ADDENDUM #4

Will County Health Department
BID PACKAGE #3 – MEP/Finishes/Carpentry/Glazing
December 6, 2018

RFI LOG
Will County Health Department
Bid Package #3 Addendum #4 12/6/18

2.01 DRAWING G301 - CODE REVIEW - BUILDING CONSTRUCTION

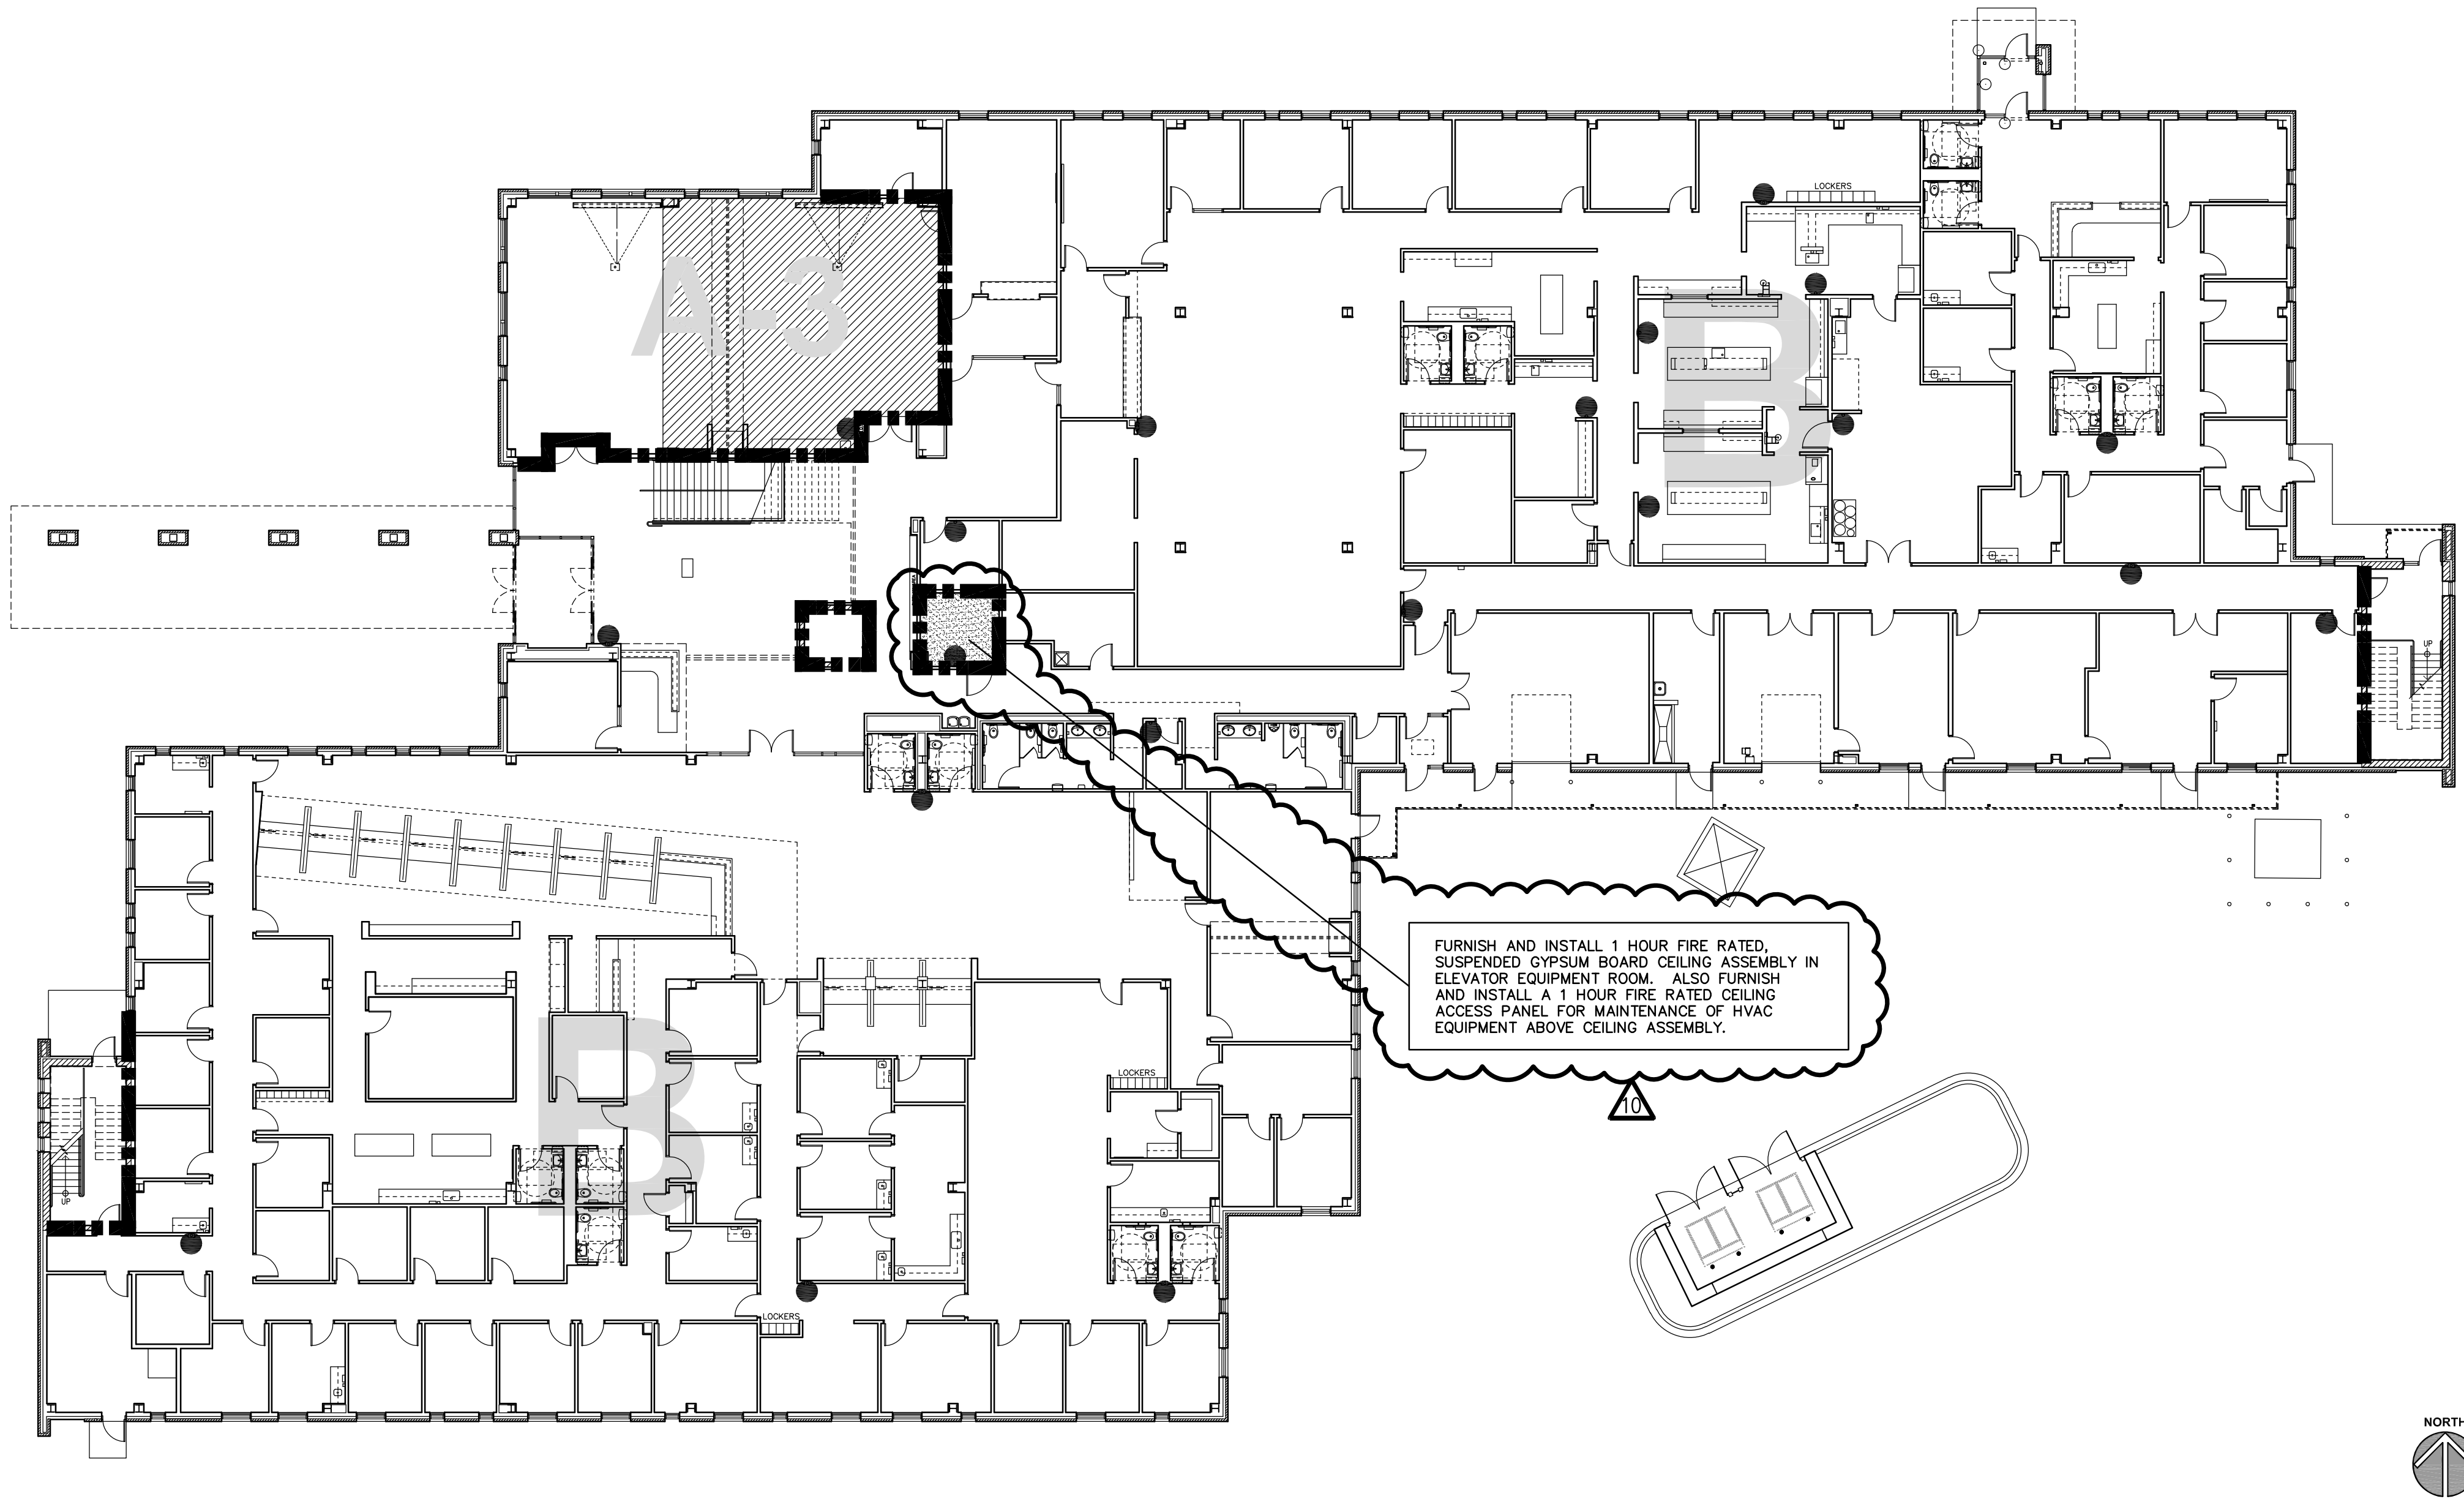
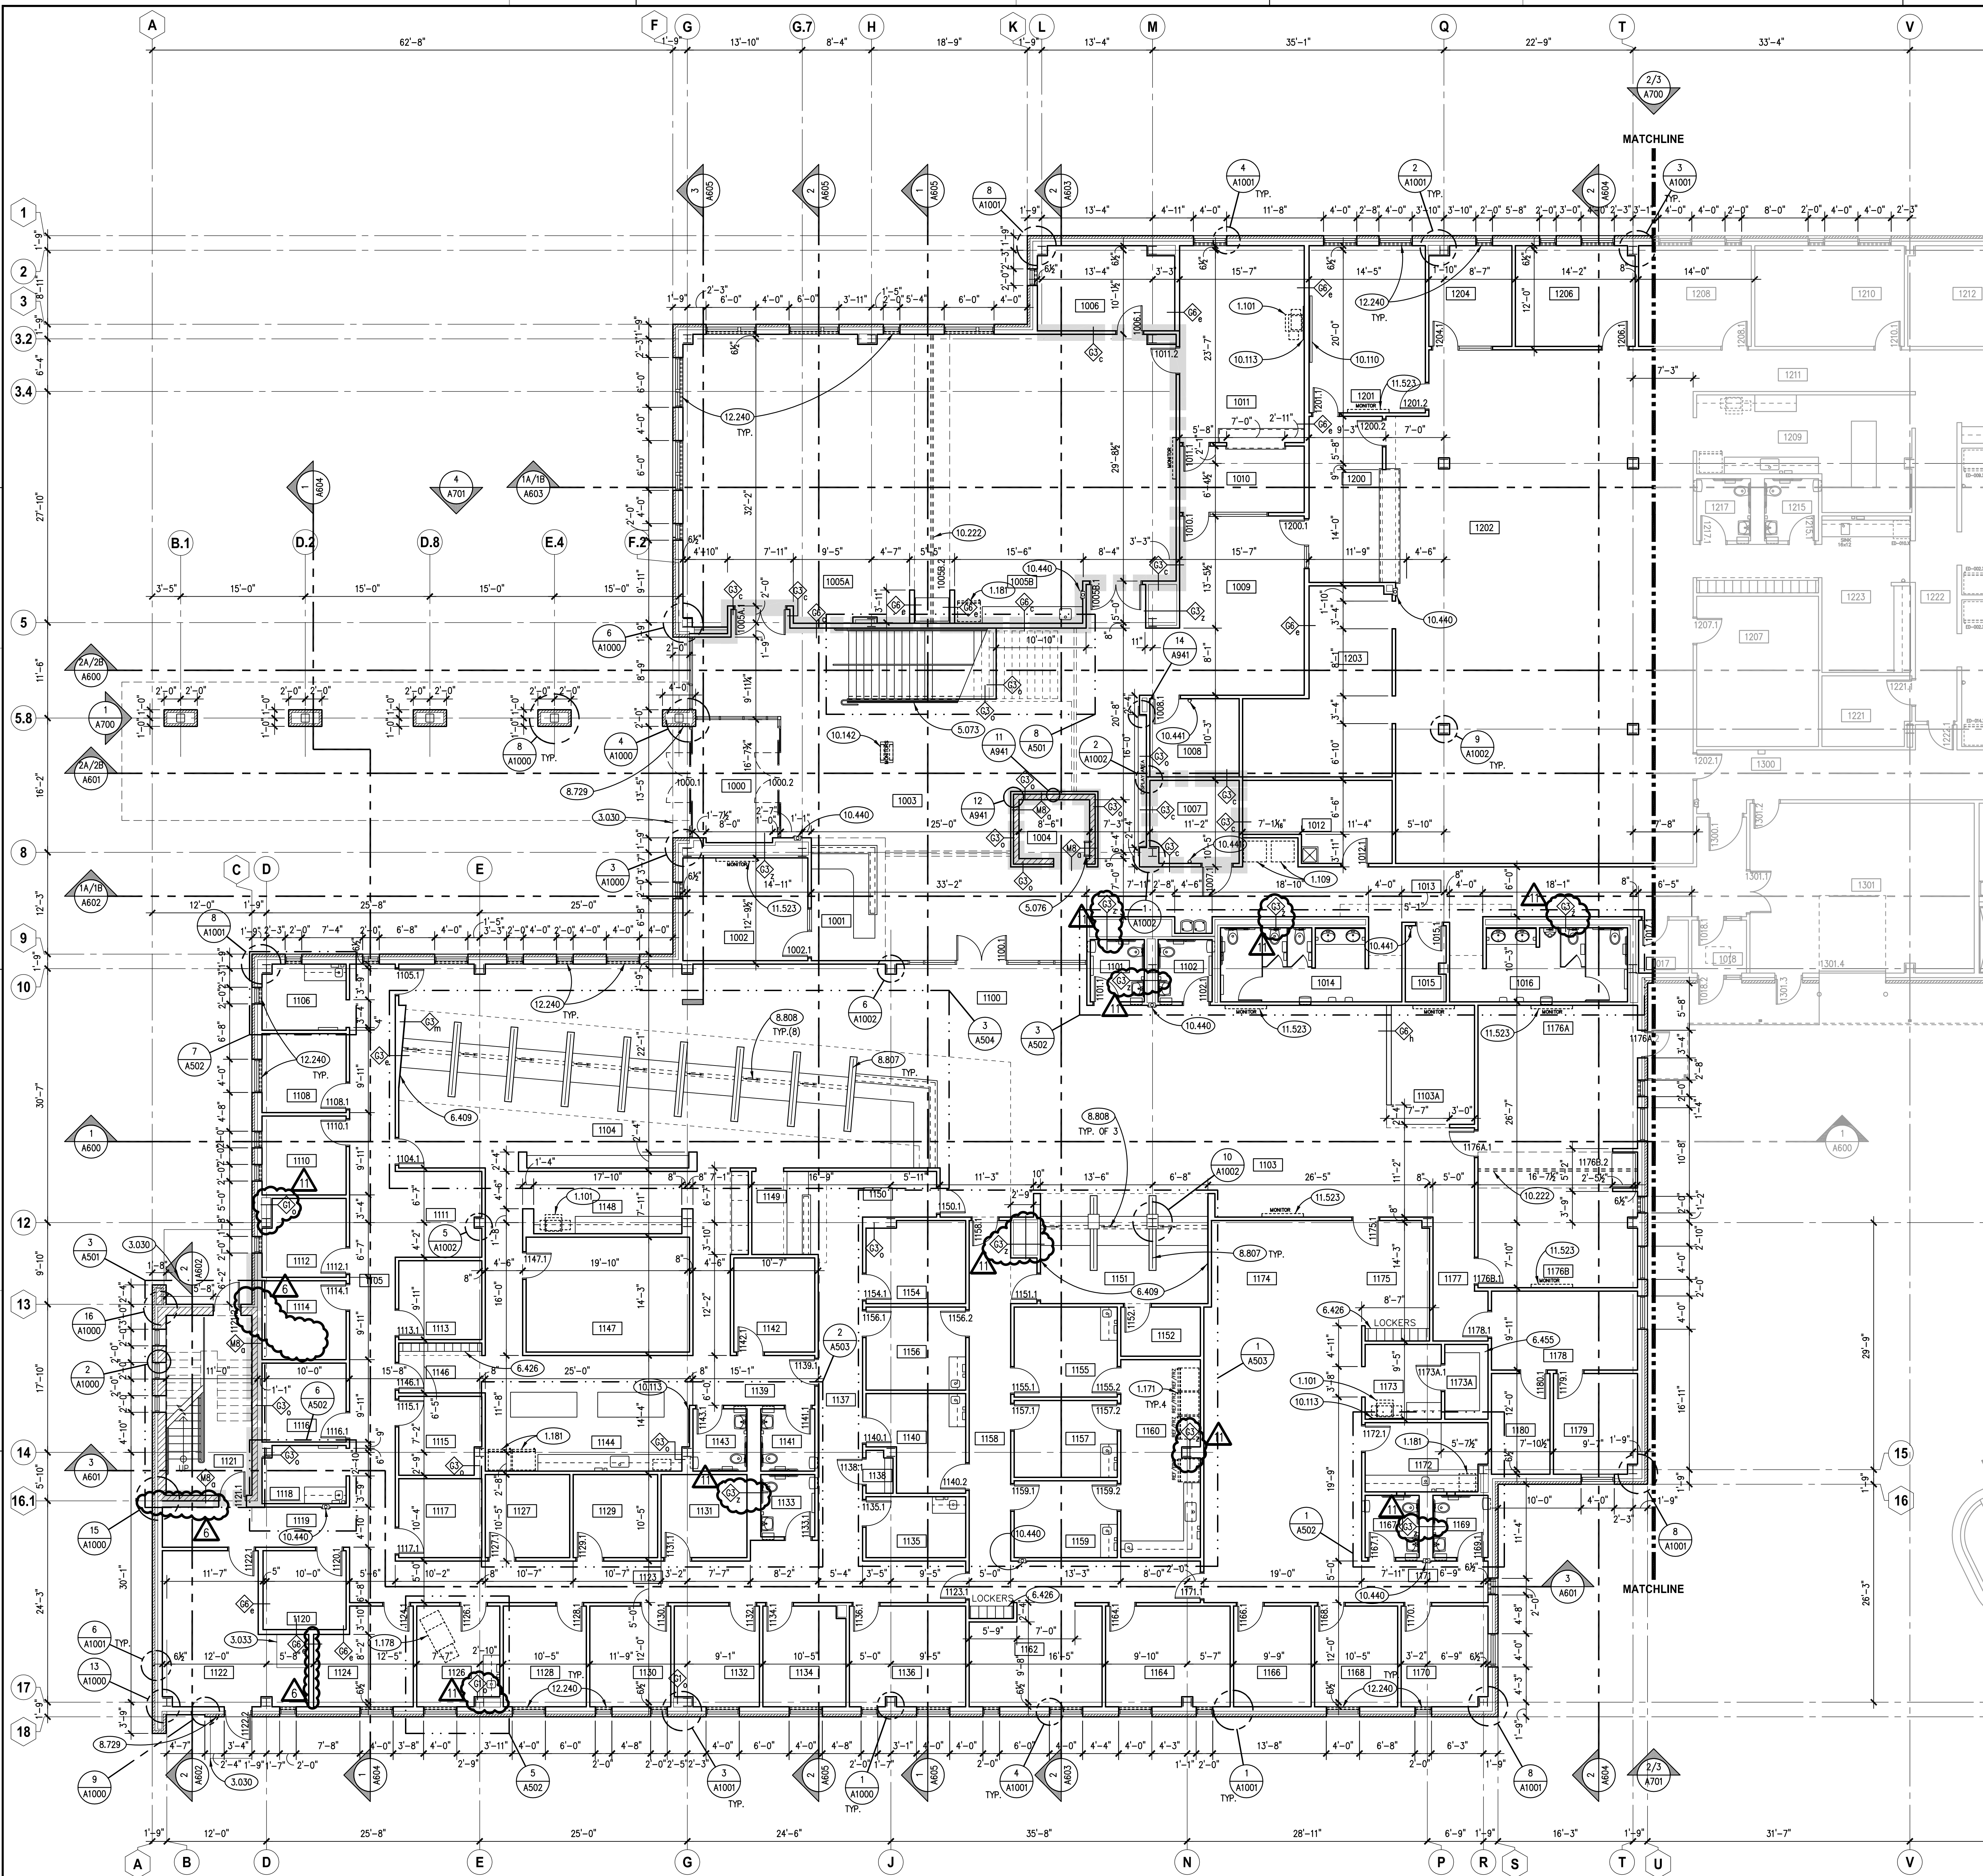
- A. Detail 2: Deleted 1-HR Fire Separation Wall Assembly graphic line image at four (4) mechanical duct locations. Fire rating of floor assembly as indicated in BP#3 - Addendum #2 (Revision Cloud 10) shall remain.

| SHEET NUMBER | A311 |

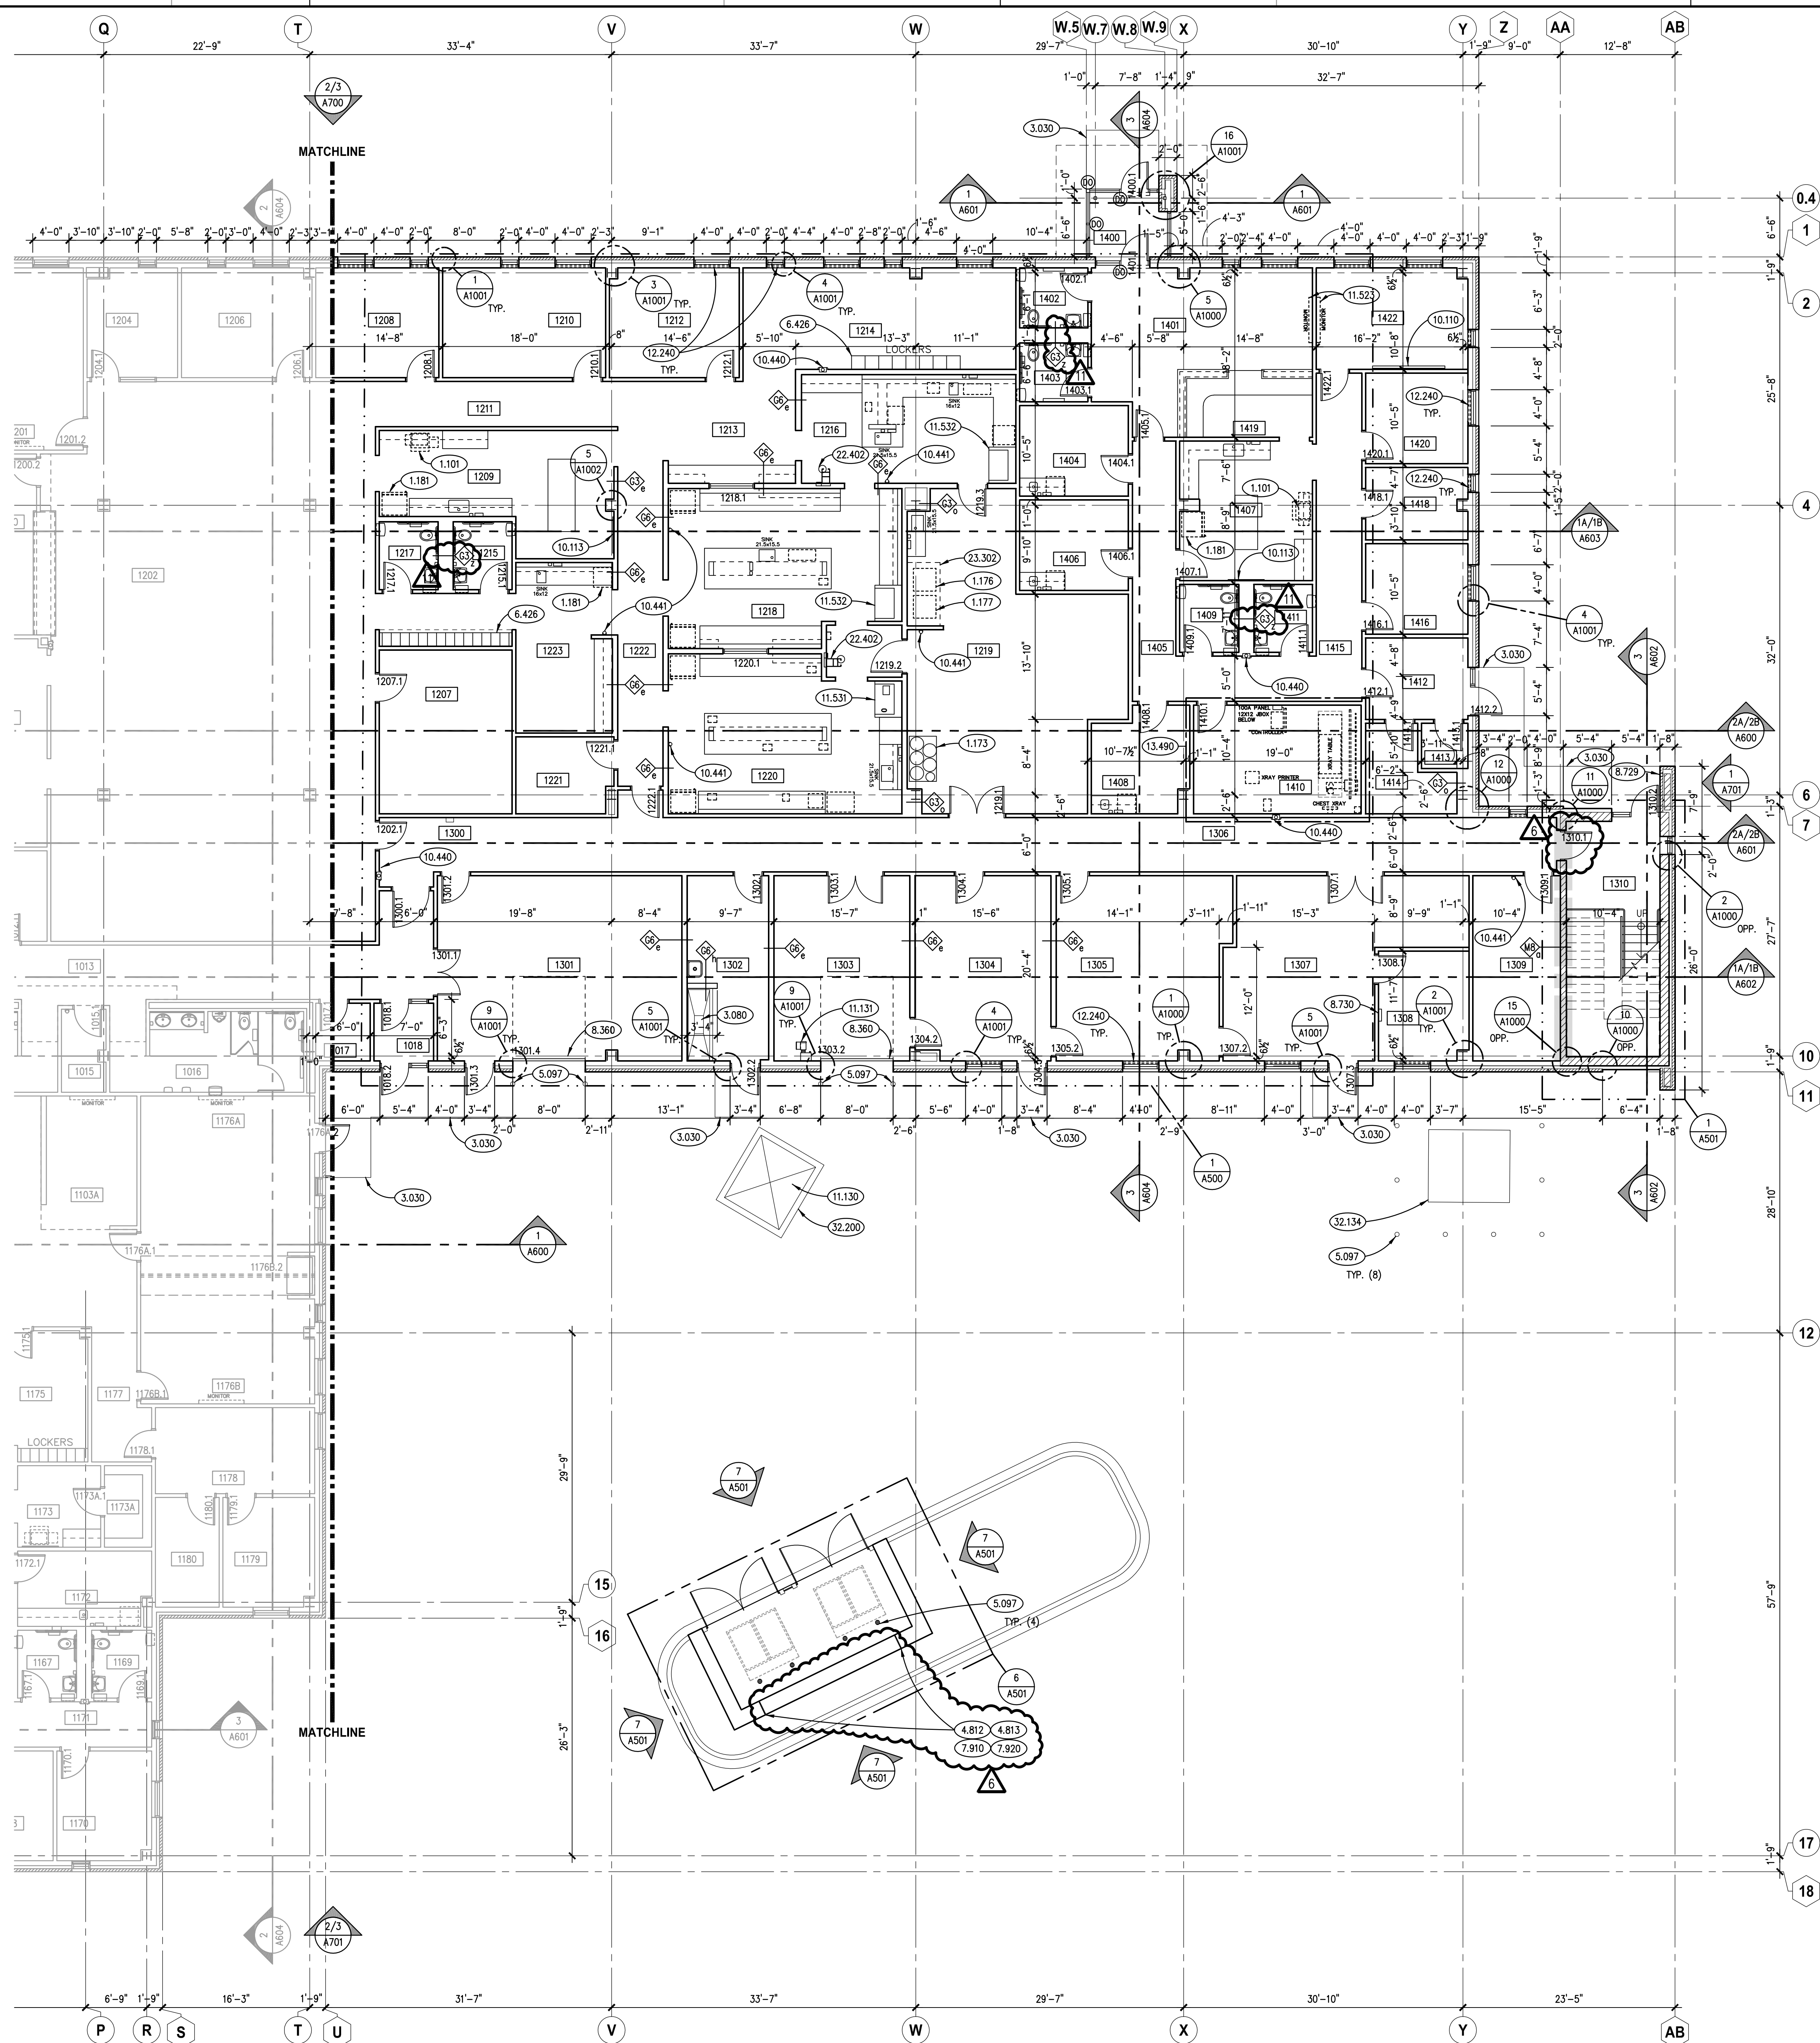
2.02 DRAWING A311 - PARTIAL FIRST FLOOR PLAN - AREA 'A'
